#29
home office/ bedrm. 4
bath
brkfst.
family rm.
kitchen
dining rm.
2-story foyer
living rm.
garage
W.I.C.
TV
fireplace
hearth as spec.
2852 twin
4062 fixed
28 french dr.
beam as req'd. (flush)
12' serving bar over 42" high kneewall
pressure pan alg. fan/light
plue Chase 1'-0"
hdr. mount
low voltage
gas stub
ice maker line
ceiling outlet for garage door opener
beam as req'd. (dropped)
line of floor above
brace wall as req'd.
to light above
3'0 door @ 10"
w/ 10" sidelites transom
2062 Triple
2852
2032
2062
2803
2-6" c.o.
7'-8" c.o.
stairs dn. 16r.
2x8 platform
open rail
sloped ceiling
COPYRIGHT © 1993 BY FRANK BETZ ASSOCIATES, INC. NOT TO BE REPRODUCED
Acknowledgment of Plans Submittal ONLY
Date 1-5-01
Date 1-8-01
FBA
FRANK BETZ ASSOCIATES, INC.
1800 LAKE PARK DRIVE/SUITE 101
FIRST FLOOR PLAN
THE HAMMOND
HOMEPLANS
DESIGNED FOR TODAY'S MARKET
DATE 4-1-94 1-21-94 6-2-94
DATE 1-10-94

m. bath
master suite
tray ceiling
brace wall as req'd.
glass enclosure over 24" high knee wall
NOTE: critical see section for wall height
attic access as req'd.
flue chase
provide pan & drain under washer
7'-6" high wall
line of 8'-0" clg.
optional closet
opt. bonus bdrm. 4
laund
bath
w.i.c.
alternate w.

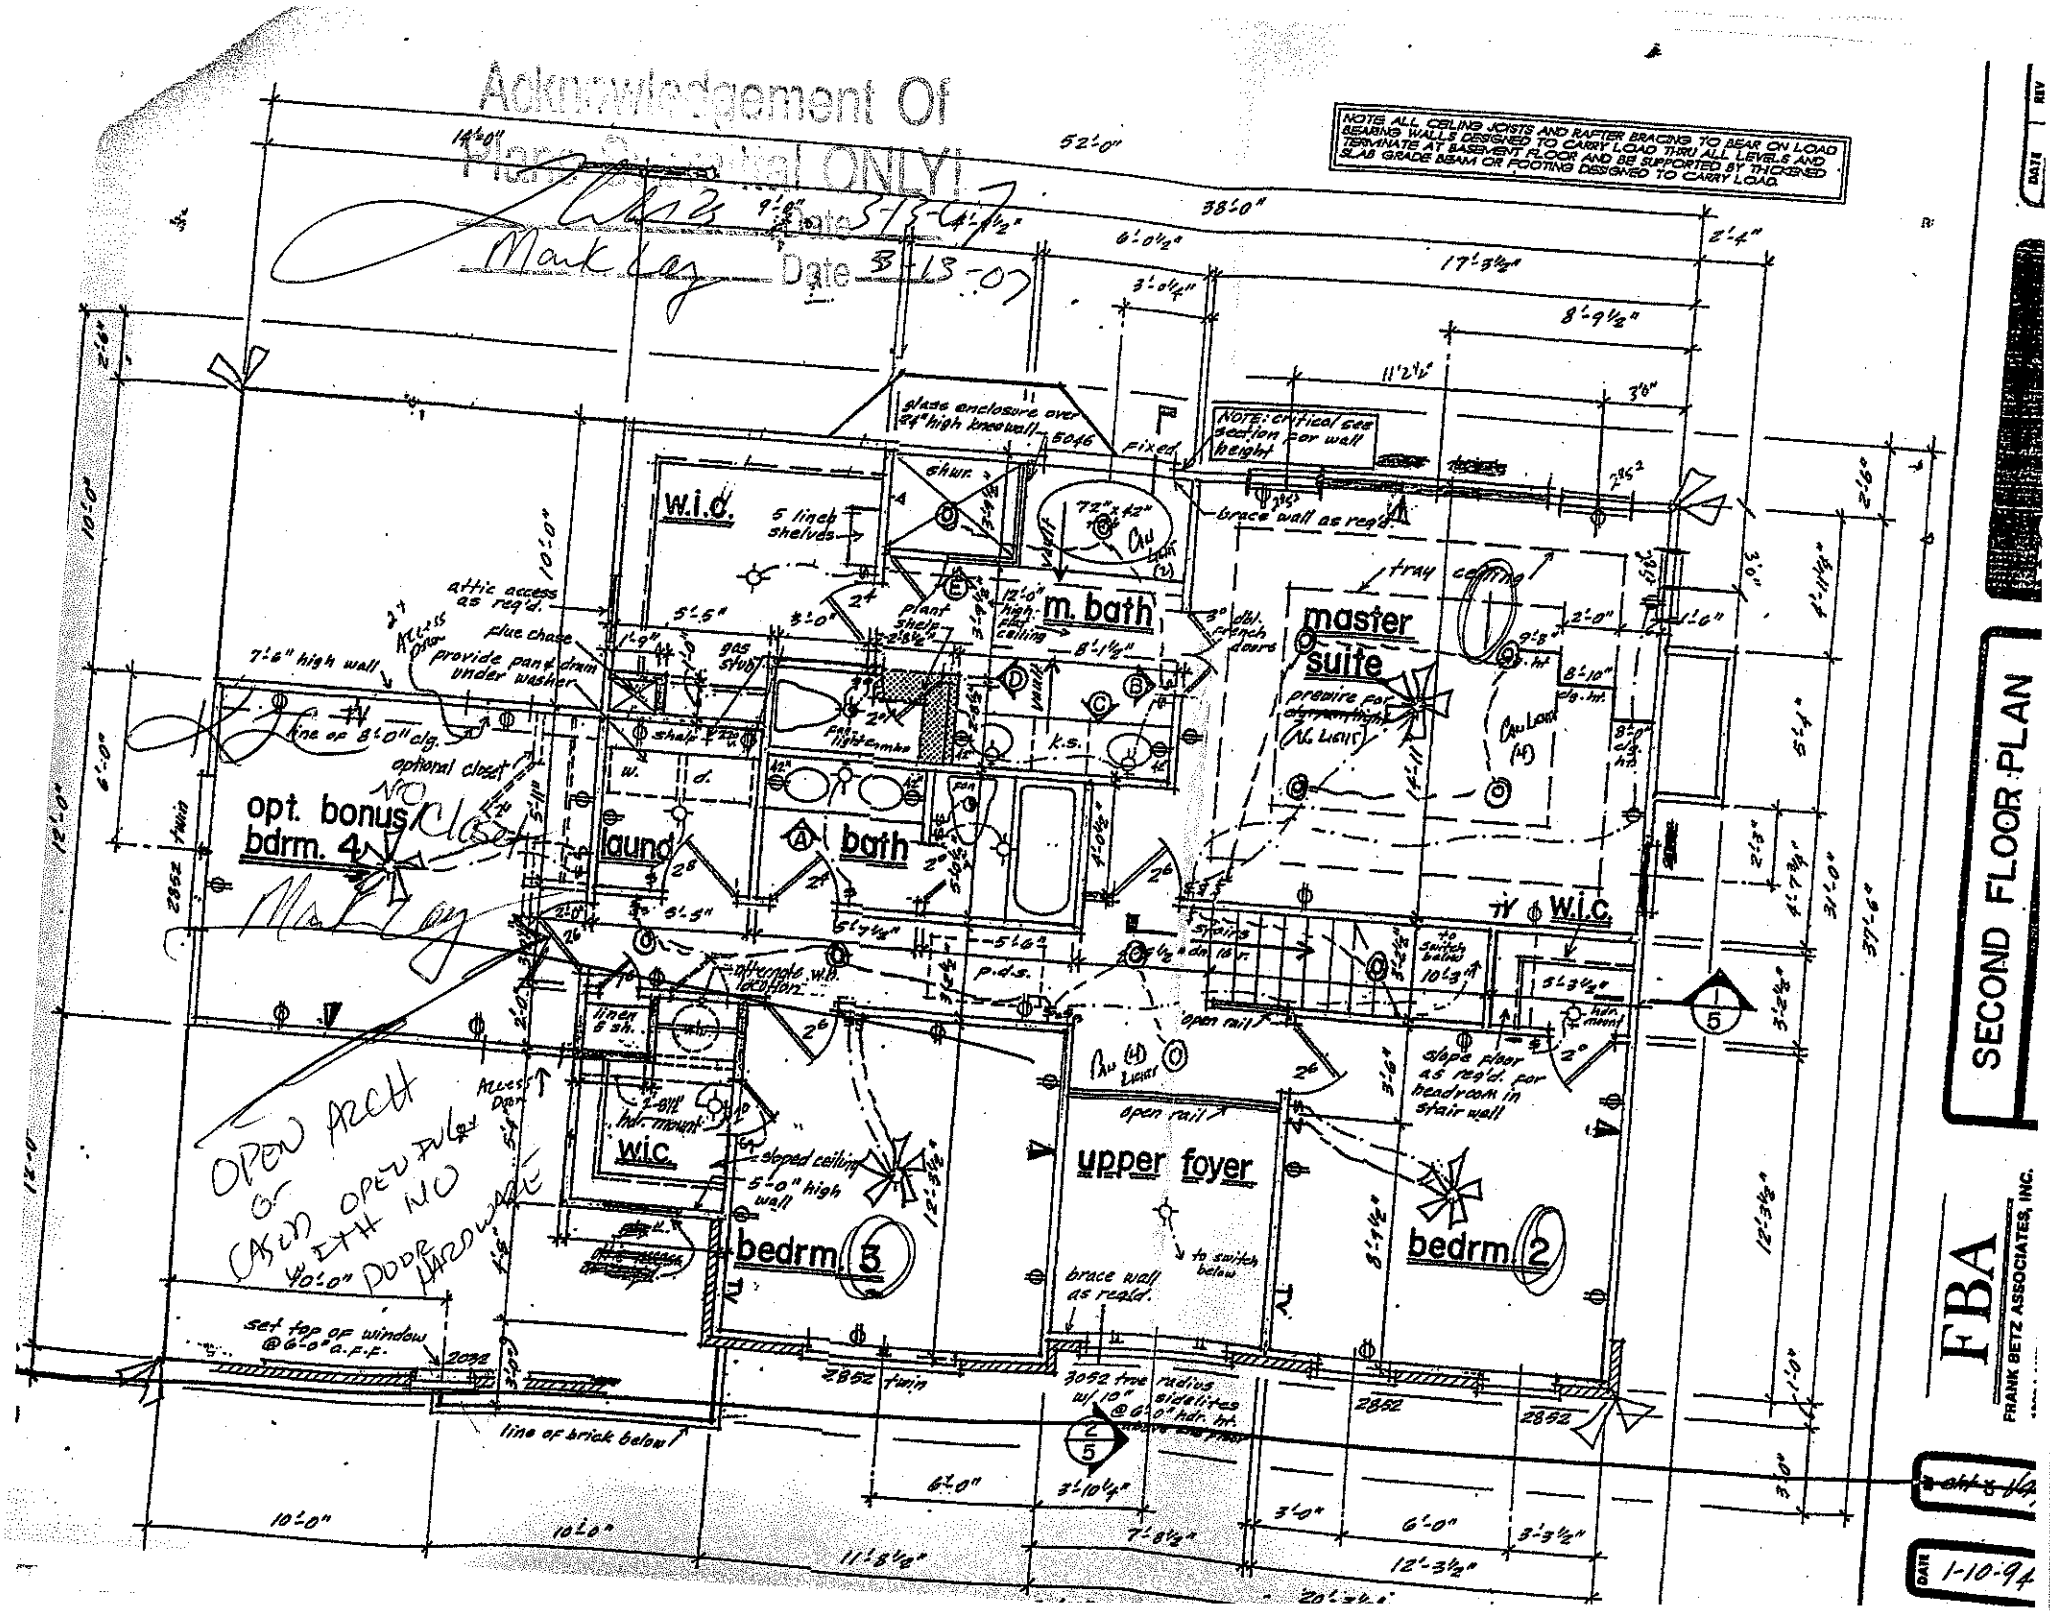
COLUMNS OR SOLID FRAMING SHOULD BE DESIGNED TO CARRY LOADS AND SHOULD EXTEND DOWN THRU THE LEVELS BELOW AND TERMINATE AT THE BASEMENT FLOOR OR AT OTHER BEARING POINTS DESIGNED TO CARRY THE LOAD.
SECOND FLOOR 1067 S.F.
TOTAL 2361 S.F.
OPT. BONUS/BDRM. 4 168 S.F.
TOTAL 2529 S.F.

Acknowledgement of
Plans Approval ONLY!
Date 3-15-07
Date 3-15-07
NOTE ALL CEILING JOISTS AND RAFTER BRACING TO BEAR ON LOAD BEARING WALLS DESIGNED TO CARRY LOAD THRU ALL LEVELS AND TERMINATE AT BASEMENT FLOOR AND BE SUPPORTED BY THICKENED SLAB GRADE BEAM OR FOOTING DESIGNED TO CARRY LOAD.
w.i.c.
5 linch shelves
